Attachment 1 - PLN20/0077 - 378 - 380 Smith Street Collingwood - Advertising S52 - Plans

**Attachment 2 - PLN20/0077 - 378-380 Smith Street, Collingwood - UD Review**

**Urban Design Review**

Proposed mixed-use development, 378-380 Smith Street, Collingwood

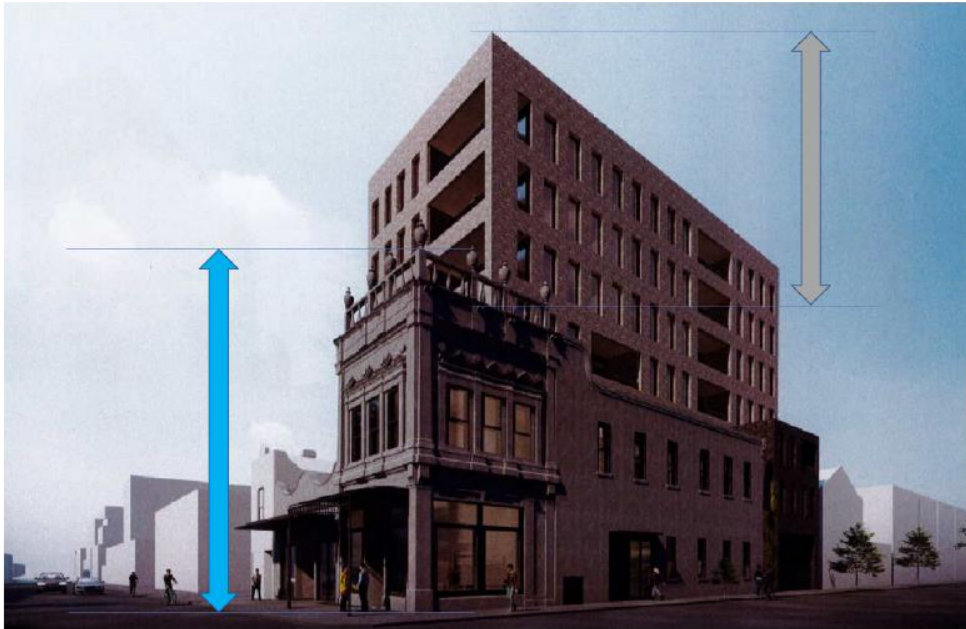
The recommended increased front setback (above) would provide further, beneficial separation of the upper level form from the heritage base, and would reinforce the primacy of the heritage fabric by increasing the sense of clear space above it.

The recessive uppermost level is not visible in this view, which also helps to reduce the apparent scale of the proposal, and the integrity of the simple design expression.

Figure 38: View 1 from the Urban Context Report, with dimensional arrows indicating that the visible leading corner of the heritage building is taller than the visible leading corner of the new upper level form. This is considered an important outcome in achieving visual balance and recessive upper levels, and avoiding the upper levels being visually dominant over the heritage buildings.

Figure 39: View 2 from the Urban Context Report, with overlay indication of clear space above heritage buildings, which is supported in terms of achieving recessive upper levels, visual balance and integrity of the retained built form.

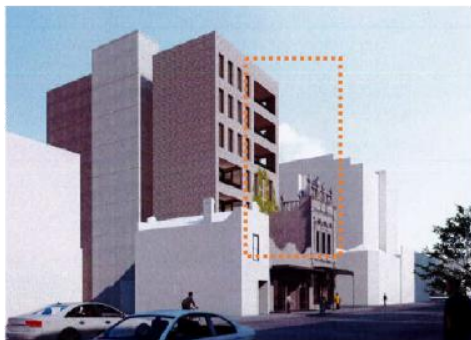
However, it is visually separate from the heritage façade, the setback being clearly visible, with clear space above the ornate part of the heritage façade at the Smith Street corner.

As above, the recessive top level is not visible in this view, but would be visible from views further back. This is supportable, because the upper level form appears lower in scale (5 levels above the street wall) and simplified in its form.

**Vehicle Crossing – Cross Section**

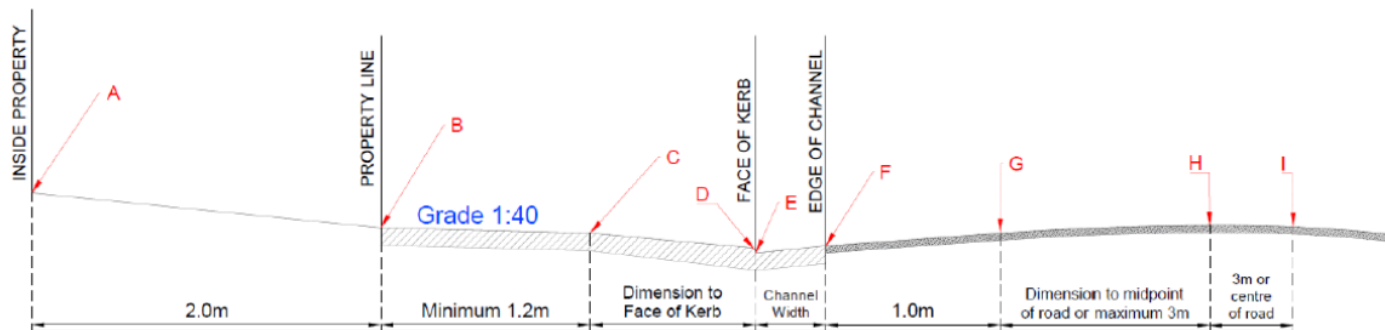
The designer is to submit a 1:20 scale cross section for each proposed vehicle crossing showing the following items:

- o Please note the cross section must be fully dimensioned. As shown in the sketch below.
- o Please show both the existing and proposed surface.
- o The maximum allowable cross-fall between points B and C is 1:40 (2.5%).
- o A bullnose (max 60mm) is permitted at point D, however not compulsory.
- o The levels shown must be exact reduced levels, to three decimal points. Interpolation of levels is not acceptable.
- o The designer must demonstrate that an 85<sup>th</sup> or 99<sup>th</sup> percentile vehicle profile can traverse the design cross section as per the Australian/New Zealand Standard ground clearance template (AS/NZS 2890.1:2004).
- o Significant level changes to the existing footpath level B to C will require additional level design either side of the proposed crossing.
- o Please include any additional levels or changes in grade that are not shown in the diagram.
